1955 PITTWATER ROAD, BAYVIEW

S4.55 AMENDED PLANS

DRAWING LIST

First Floor Plan

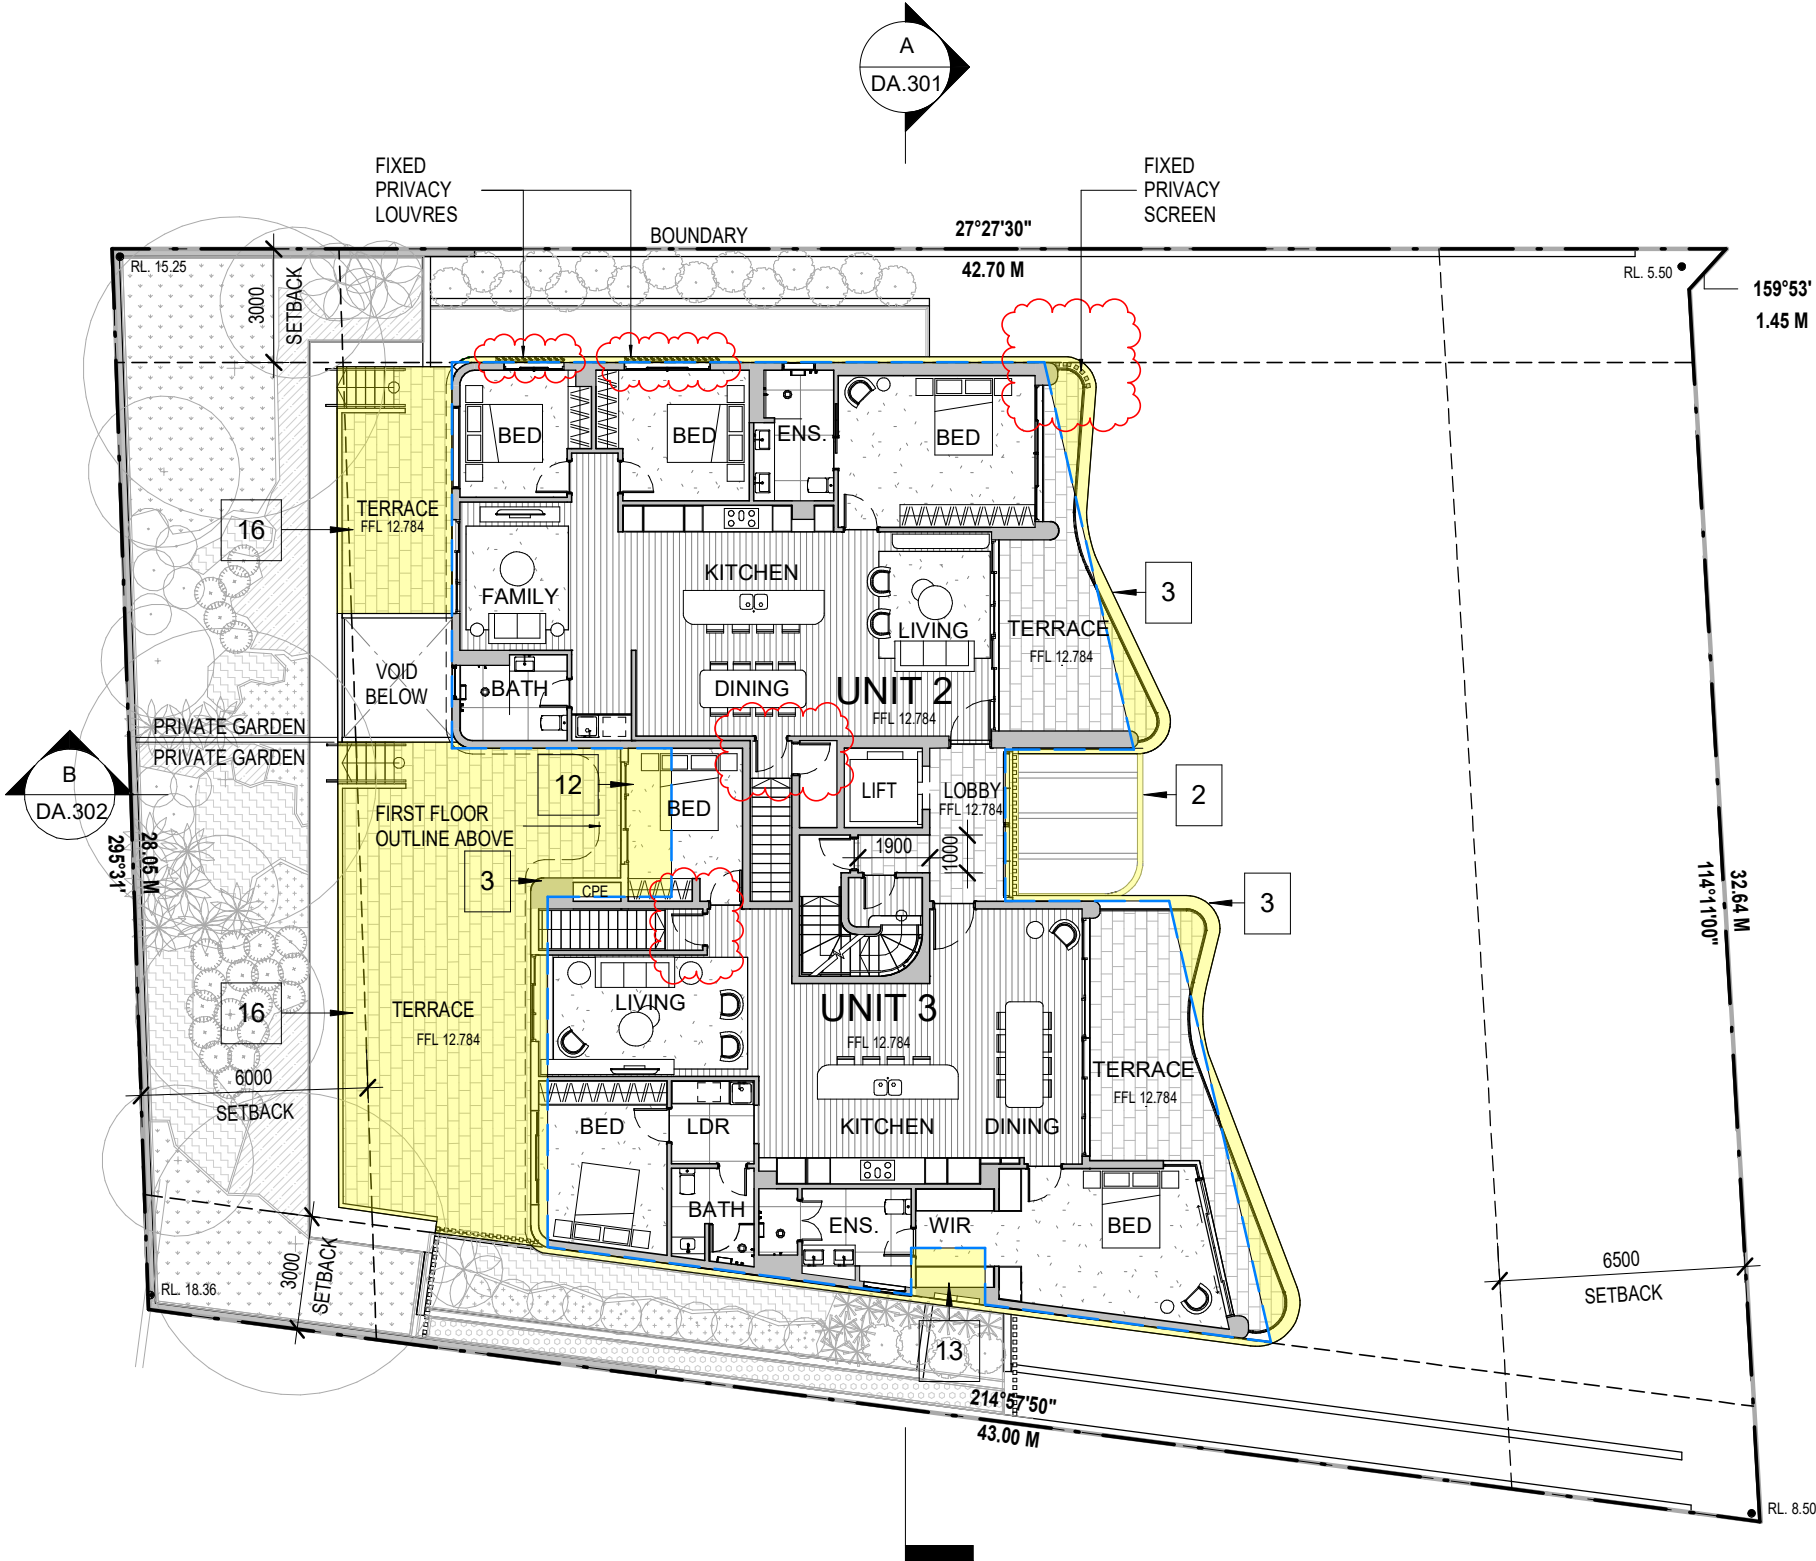
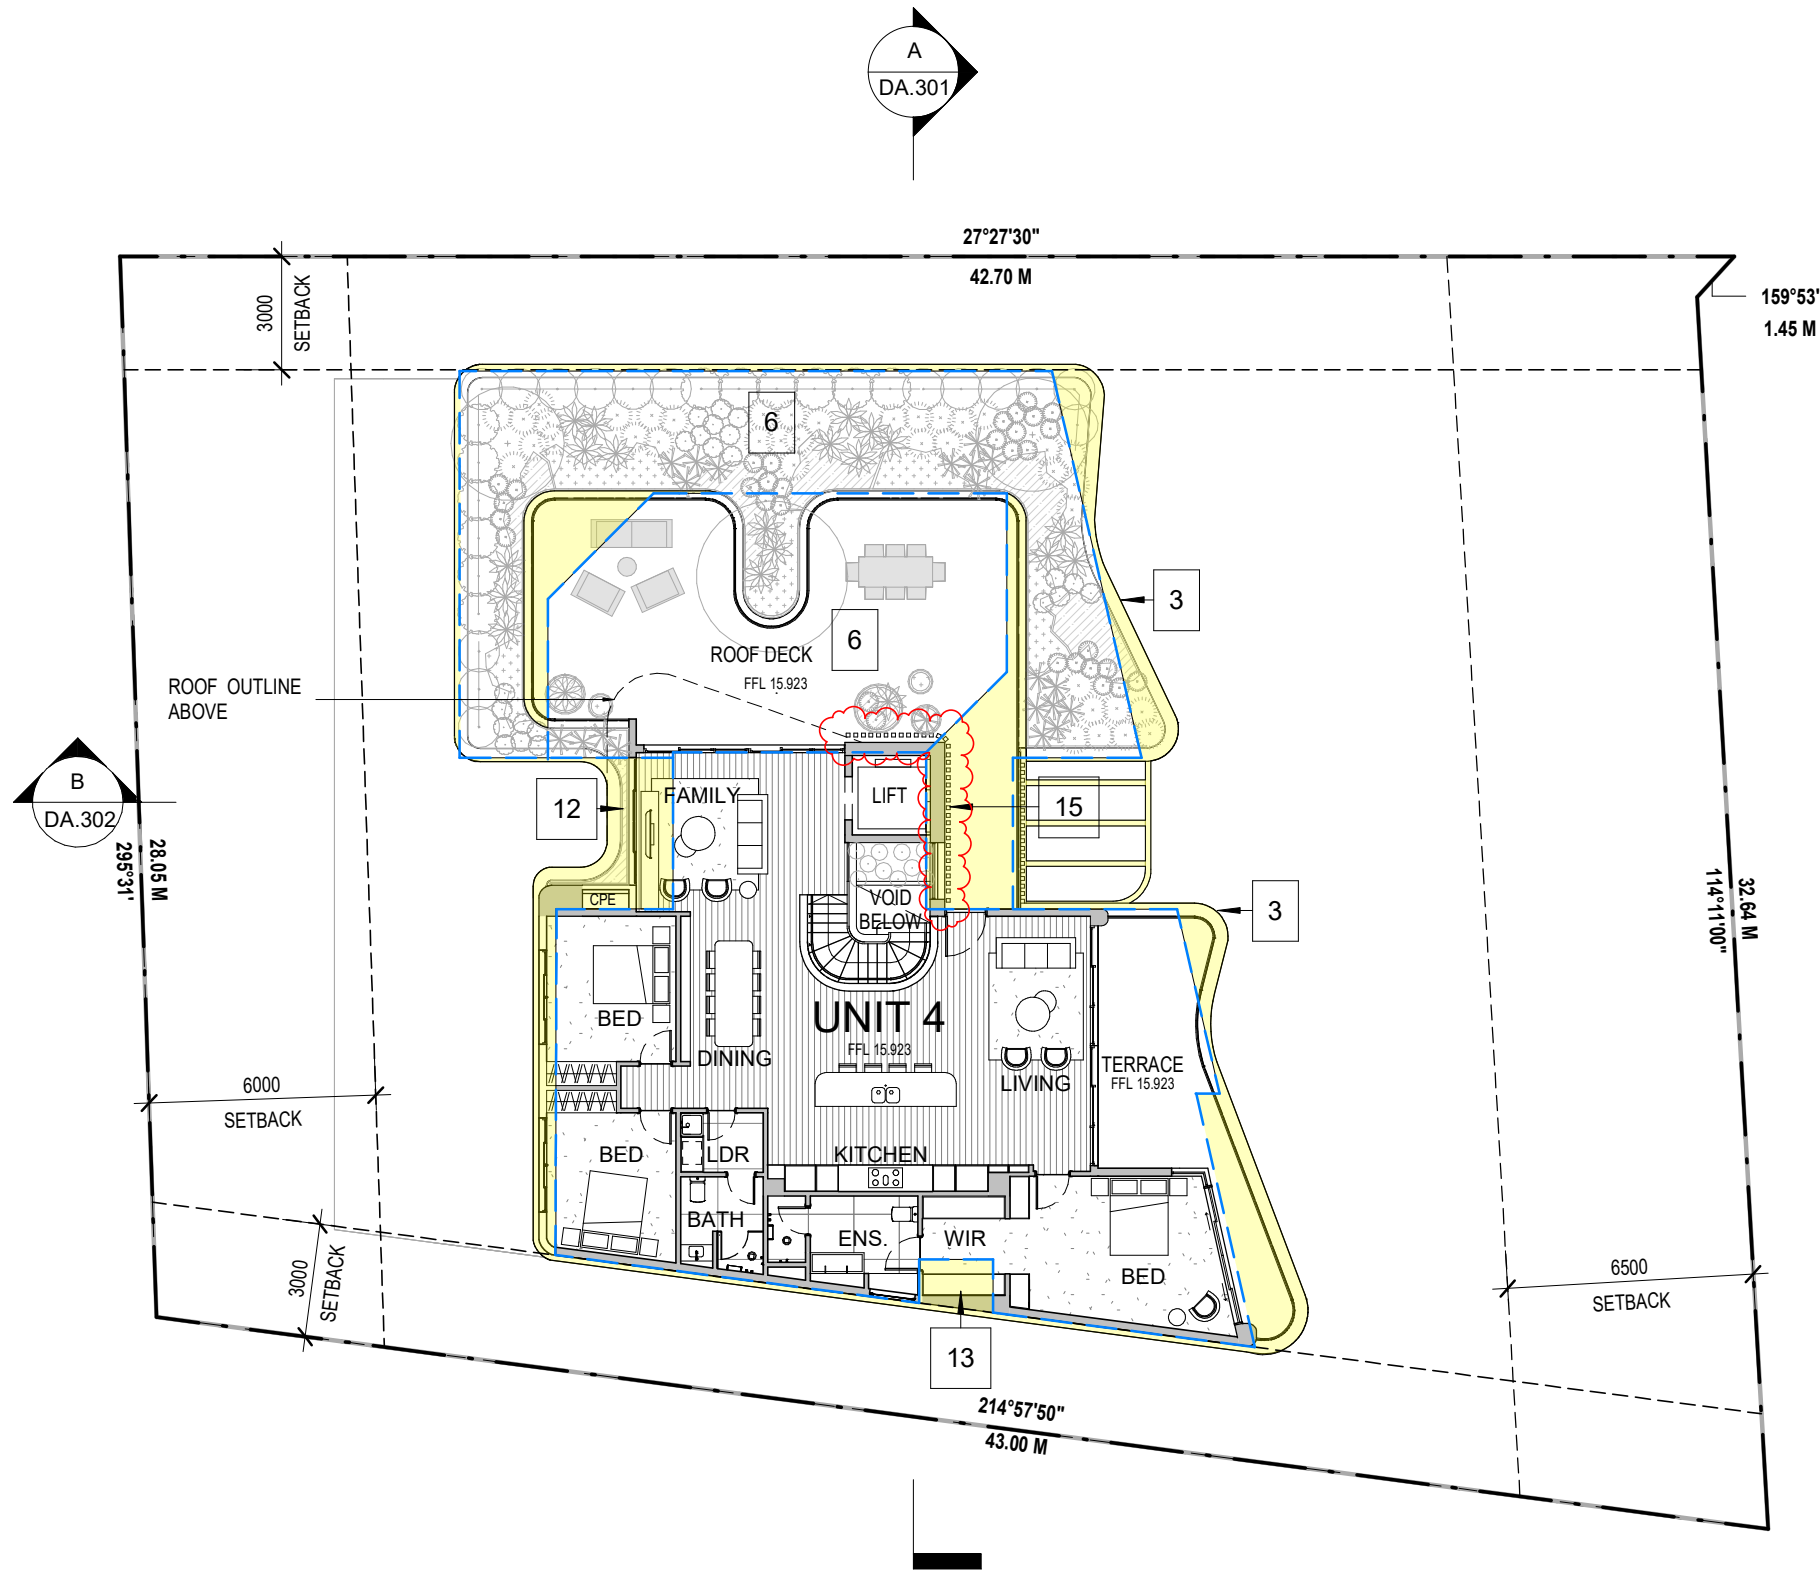
1. **Entry Pedestrian Ramp** - Increased pedestrian ramp width to 1600mm for accessibility
2. **Building Entry** - New awning and vertical louvre screen to increase sense of entry.

3. **Balcony Articulation** - New curved balconies for improved aesthetics. Increase in outdoor private open space area and solar access for improved amenity

4. **Fencing** - New fencing to provide safety and security
5. **Roof** - New rooftop plant enclosure to comply with services requirements
6. **First Floor Roof Deck/ Landscaping** - Change in configuration of First Floor roof deck to integrate with overall building aesthetics. New landscape buffer around perimeter of First Floor roof deck for improved privacy and softening of built form

7. **Roof & Floor RL** - Adjustment in floor-to-floor heights to reflect structural and building services requirements.
8. **Vehicular Access** - Design development to comply with accessibility & Australian Standards.

9. **FRNSW Requirement** - to provide hardstand & fire hydrant booster assembly , requiring removal of tree T3 (Refer to Arborist Report).
10. **Carpark Floor Plan** – Parking re-configuration within approved footprint.

11. **Lower Ground Floor Plan** – Increase in Unit 4 storage area to accentuate recess and alignment between the two modulated built forms. Louvred door and panels for maintenance and ventilation. New landscaped terrace to integrate with cascading balconies above and overall building aesthetics.

12. **Unit layouts** - Internal reconfiguration and increase in unit size for improved amenity.
13. **Elevations** - Removal of wall break in east elevation of Units 3 and 4. Revised façade and window treatments associated with plan amendments

14. **Boundary Fence** - 1.8m high painted fencing capped and lapped in Dulux 'Winter Fog'
15. **Vertical Screening** - Continuation of vertical screening over lift shaft to accentuate recess between the two modulated built forms

16. **Proposed Terrace Extension**
